## ZONING BOARD OF ADJUSTMENT CONSIDERATION ITEM

### CITY OF FAIR OAKS RANCH, TEXAS

AGENDA TOPIC: The Zoning Board of Adjustment of the City of Fair Oaks Ranch, Texas, will conduct a public hearing to receive public testimony on the Variance Application No. ZBOA 2022-09-14 from Ms. Carmen Groth, applicant, on behalf of the property owner, G Leon Family Partnership LTD to grant variances for the property located at 28313 Leslie Pfeiffer Drive, Boerne, TX.

## Illustration 1: Applicant's Proposal (Requested Variances Highlighted)

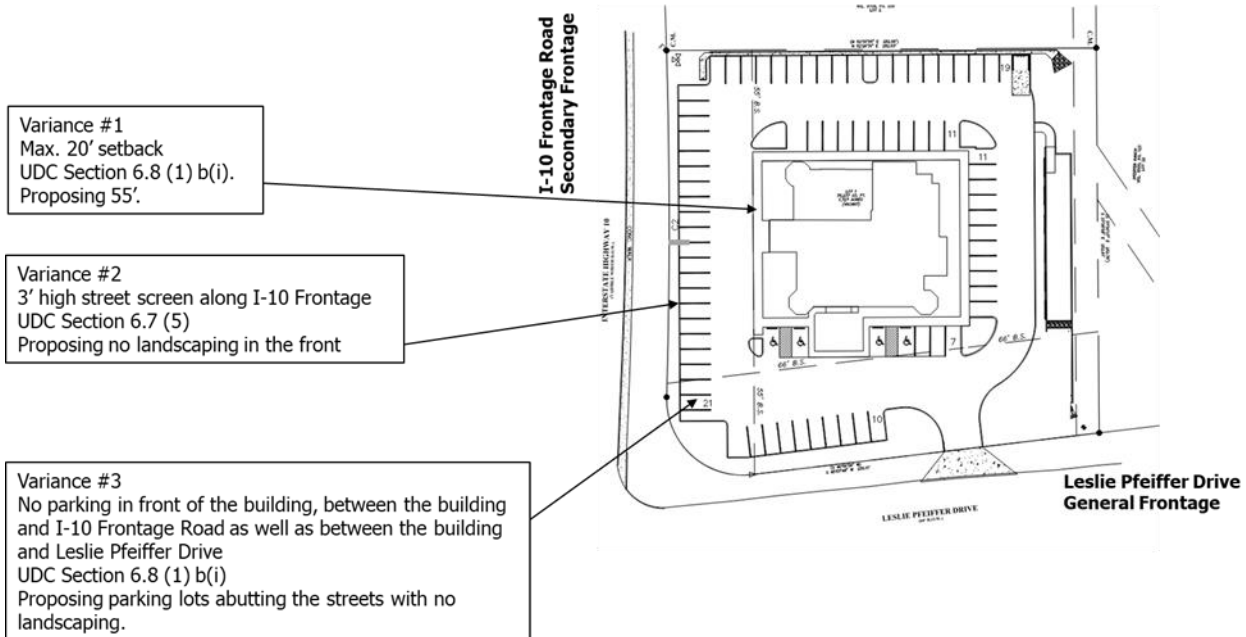
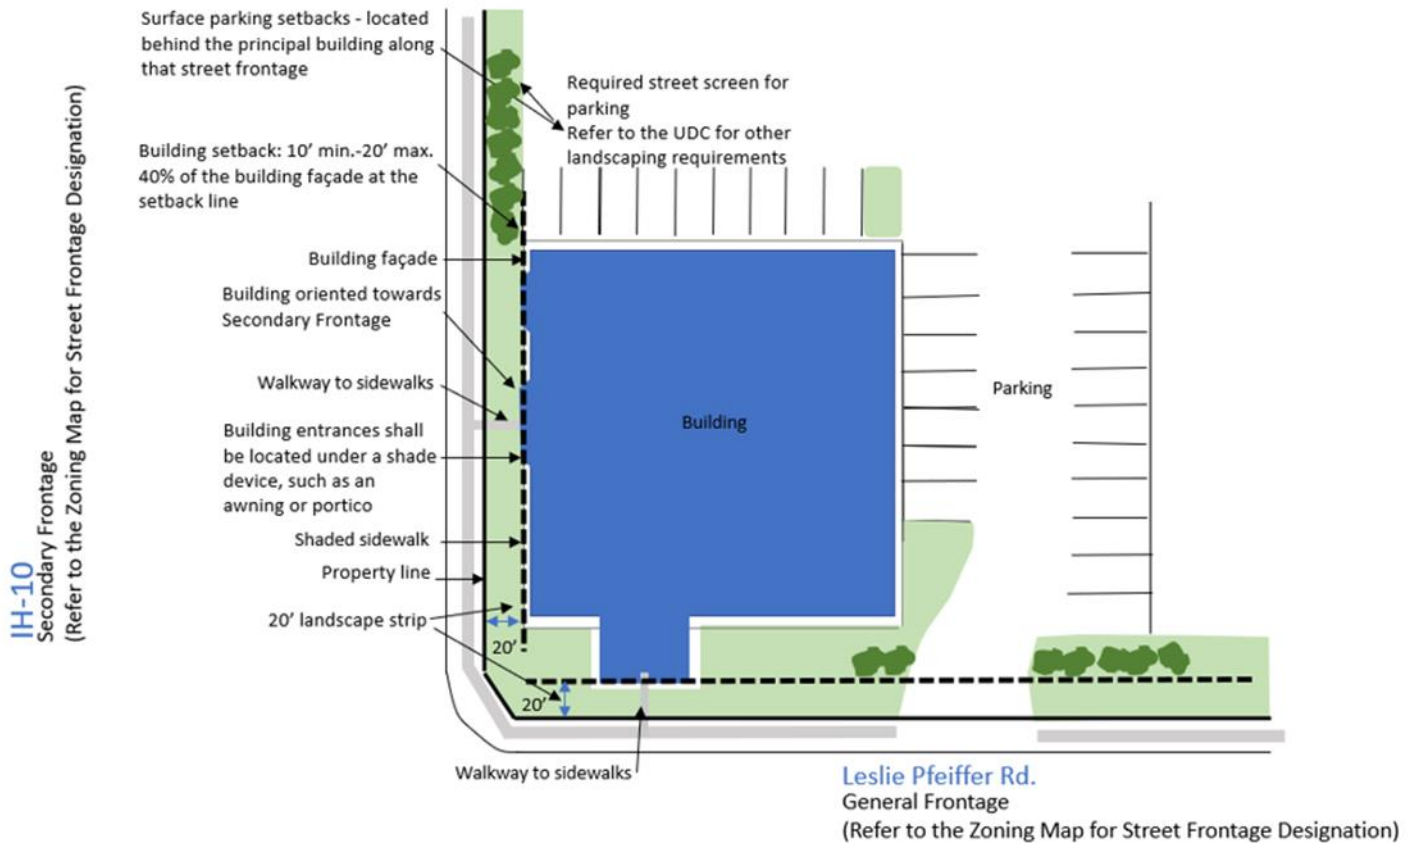
1. Variance from Section 6.8 (1) b (i) – vary the 20' maximum setback requirement along Secondary Frontage (I-10 Frontage Road) to 55'.

The proposed front setback will be 55' to locate parking along I-10 Frontage Road. This will exceed the maximum setback limit along Secondary Frontage (I-10 Frontage Road) for Mixed Use Zone.

2. Variance from 6.7 (5) (a)– Eliminate the required 3' high landscaping screening strip between parking and street.

There is room for landscape screening, however, the existing site plan does not propose any screening.

3. Variance from the requirements of UDC Section 6.8 (1) (d) (i) - allow parking in front of the building, between the building and I-10 Frontage Road as well as between the building and Leslie Pfeiffer Drive.

The applicant is proposing double the parking spaces required. Current site plan proposes 93 parking spaces whereas the UDC requirement is only 47 spaces.

**Finding:** Per the **Illustration 2: Schematic Diagram Showing Compliance (prepared by staff)**, it is staff's opinion that the site can be redesigned to meet this requirement. The applicant has not identified any constraints on the property that would prevent the applicant from meeting this UDC requirement. The criteria in UDC Sec. 3.9 (9), do not apply and a deviation is not warranted. Adherence to this requirement will not prohibit or unreasonably restrict the utilization of the property.

**Finding:** It is staff's opinion that the 3' high street screen can be provided by redesigning the site to meet this requirement as shown in **Illustration 2: Schematic Diagram Showing Compliance (prepared by staff)**. The criteria in UDC Section 3.9 (9), do not apply and a deviation is not warranted. Adherence to this requirement will not prohibit or unreasonably restrict the utilization of the property. Removal of this landscaping screen will result in no landscaping at all between the building and I-10 Frontage Road, which will adversely affect the character of the area.

**Finding:** It is staff's opinion that site can be redesigned to meet this requirement as shown in **Illustration 2: Schematic Diagram Showing Compliance (prepared by staff)**. The criteria in UDC Sec. 3.9 (9), do not apply and a deviation is not warranted. Adherence to this requirement will not prohibit or unreasonably restrict the utilization of the property. Granting this Variance will be not in conformance with the purpose of the Mixed Use Village district, as stated in the UDC and Hill Country Design aesthetic.

Figure 7-16 Illustration showing required Street Screen along all frontages with surface parking in the setback zone.

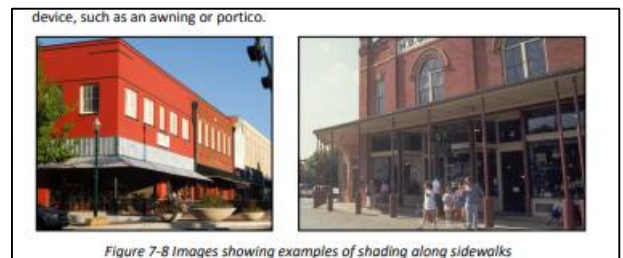
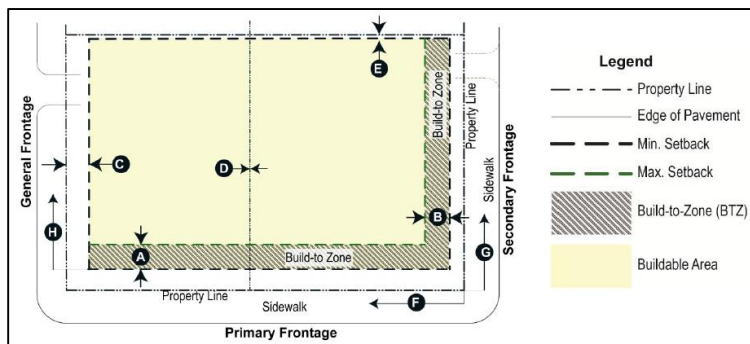
1. A 25 foot wide landscaped strip along the street frontages, with trees and shrubs as required by **Figure 7-16 (UDC Sec. 7.7)** below.
2. Street trees: Spacing shall be an average of 30 feet on center. The minimum caliper size for each tree shall be 2 inches and shall be a minimum of 8 feet in height at planting. Each tree shall be planted in a planting area no less than 36 sq. feet. Species shall be native or adapted species selected from the Approved Plant List, found in Appendix B of the UDC.
3. Shrubs: 3-foot landscaped vegetative screen composed of shrubs planted to be opaque at maturity (see **Figure 7-16**).
4. All other landscaping requirements shall be met.

**Illustration 2: Schematic Diagram Showing Compliance (Shared with the applicant in February 2022)**

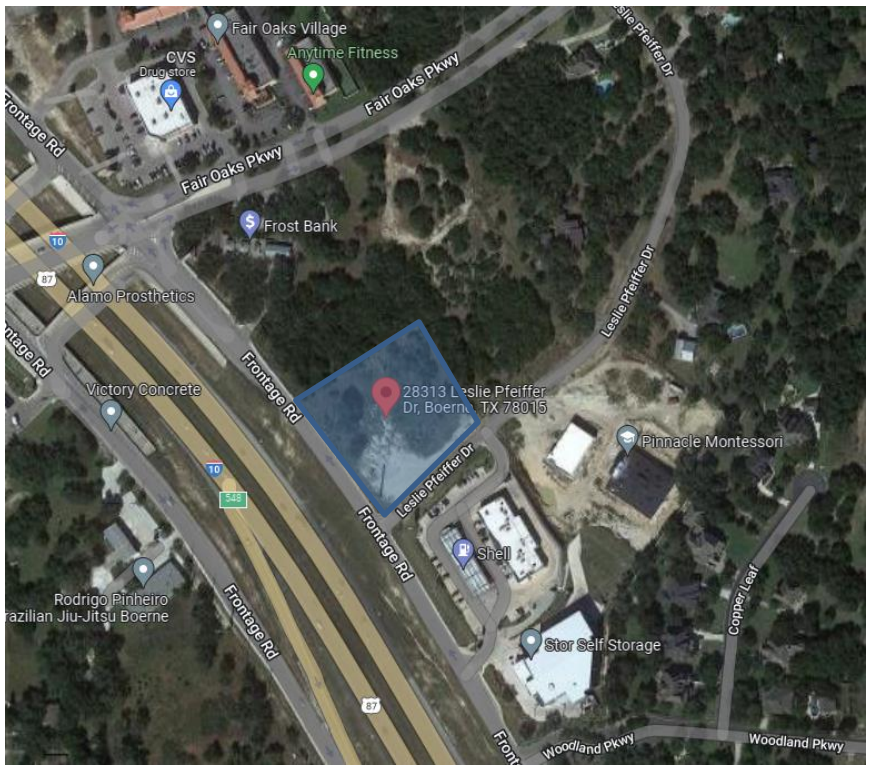
Preliminary review of the site indicates that the requirements of the UDC in terms of access, landscape screening, parking setback from the street, and number of parking spaces can be met by re-designing the layout per the **Illustration 2: Schematic Diagram** below. Staff's review of each Variance is listed below:
